## MITIGATION PLAN

**Round Hill Branch Restoration Site  
Buncombe County, North Carolina  
DMS Project Number 100066  
DEQ Contract 7534  
USACE AID #: SAW-2018-01168  
NC DWR#: 20181031 v1**

Subject: Round Hill Branch Restoration Site  
Mitigation Plan Review – Response to IRT Comments  
French Broad River Basin - 06010105  
Buncombe County, North Carolina  
DEQ Contract No. #7534  
DMS Project #100066  
USACE AID #: SAW-2018-1031 v1

Subject: Round Hill Branch Restoration Site  
Draft Mitigation Plan Review  
French Broad River Basin – CU# 06010105  
Buncombe County  
DMS Project ID No. 100066  
Contract # 7534

**FIGURE 10. PROPOSED MONITORING PLAN  
ROUND HILL BRANCH RESTORATION SITE  
BUNCOMBE COUNTY, NC**

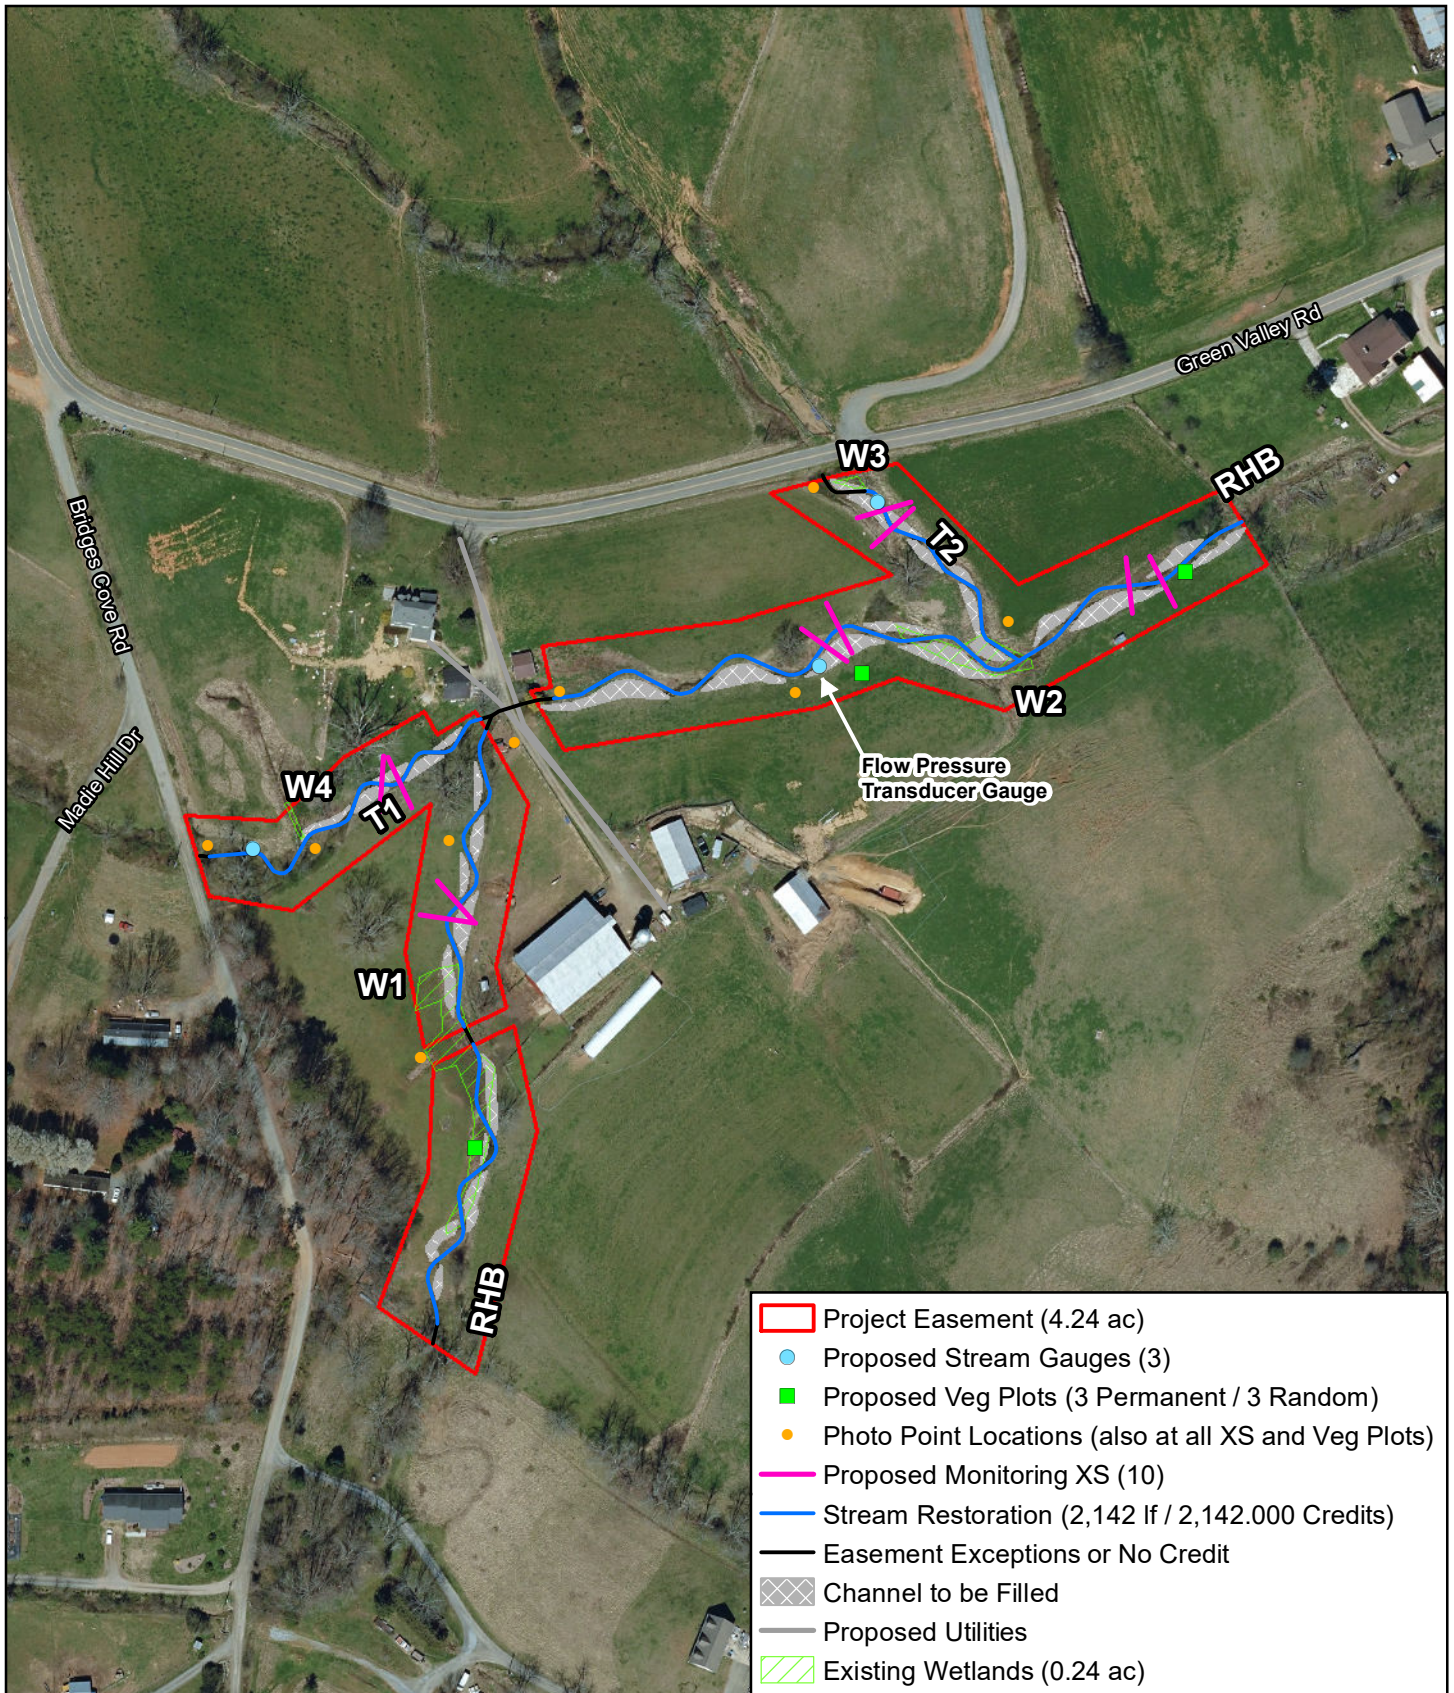
10. Figure 10: Please also include photo points at the culverts along Green Valley Rd. and Bridges Cove Rd

13. Figure 10 –

- a. Please add a T1 flow gauge and shift the T2 gauge slightly downstream to within the creditable reach.

- c. Please confirm that photo points for veg plots and cross sections not shown will be included in the annual monitoring reports. Please also add a photo point downstream of the driveway culvert crossing.

***These have been added to the figure.***

***We have updated Figure 10 and in Table 18 (formerly Table 19) to include the extra stream gauge. We have deleted the errant asterisk.***

***We have added a reference to these two additional plots in the legend.***

***Yes, we include photos for all veg plots and cross-sections in our monitoring reports; we have added to the legend that these photos are also included. We have also inserted the requested photo point downstream of the driveway crossing.***
